Model Error Resolution Document

1. Originator: Alicia Aragon	2. Date: 05/20/08	3. ERD No. MDL-NBS-HS-000023 ERD 02
4. Document Identifier: MDL-NBS-HS-000023 REV 01 AD 01	5. Document Title: Simulation of Net Infiltration for Present-Day and Potential Future Climates	
6. Description of and Justification for Change (Identify applicable CRs and TBVs):

This ERD addresses CR 12144 which identifies an error in Figure 7.2.1.2-2[a] of *Simulation of Net Infiltration for Present-Day and Potential Future Climates* (MDL-NBS-HS-000023 REV 01 AD 01 [DIRS 182145]).

Figure 7.2.1.2-2[a]. Comparison of Recharge Estimates for Nevada Hydrographic Areas/Subareas with MASSIF Estimates of Net Infiltration at Yucca Mountain

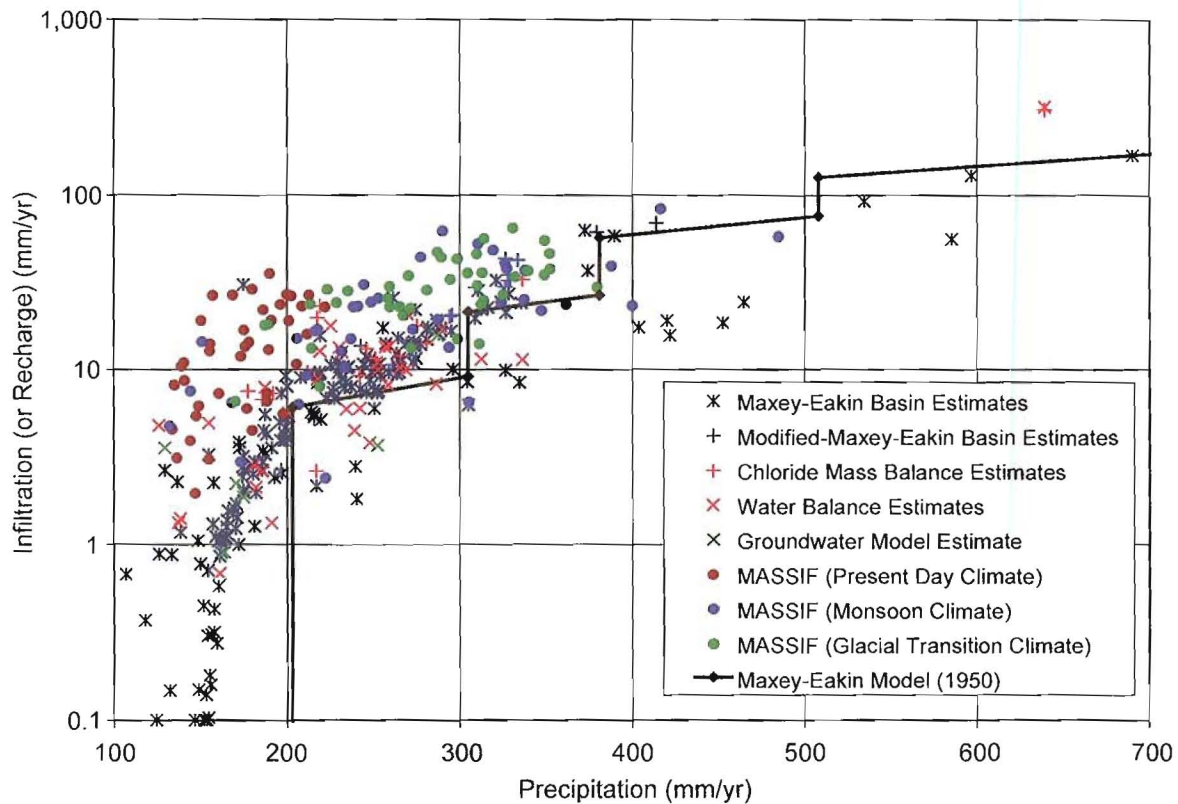
"In MDL-NBS-HS-000023 REV 01 AD 01 Figure 7.2.1.2-2[a], the y-axis is plotted on a log scale. The minimum value is shown as 0. This should be 0.1. This figure also appears in DTN: SN0801T0502206.049, file "Recharge_models_vs_MASSIF_ver3.xls" on worksheet "Fig7212-2".

Other than the editorial change in the figure, this error has no effect on the output of the MDL-NBS-HS-000023 REV 01 AD 01."

To resolve this issue, Figure 7.2.1.2-2[a] on page 7-52 of MDL-NBS-HS-000023 REV 01 AD 01 is to be replaced with the corrected figure as shown below.

This editorial error is also corrected in Rev 001 to output DTN: SN0801T0502206.049, file: *Recharge_Models_vs_MASSIF_ver4.xls*, worksheet: "Fig7212-2." In Section 9.4[a] on page 9-21 of MDL-NBS-HS-000023 REV 01 AD 01 [DIRS 182145], the submittal date for DTN: SN0801T0502206.049 is to be replaced with 05/22/08 to reflect the revision to the DTN.
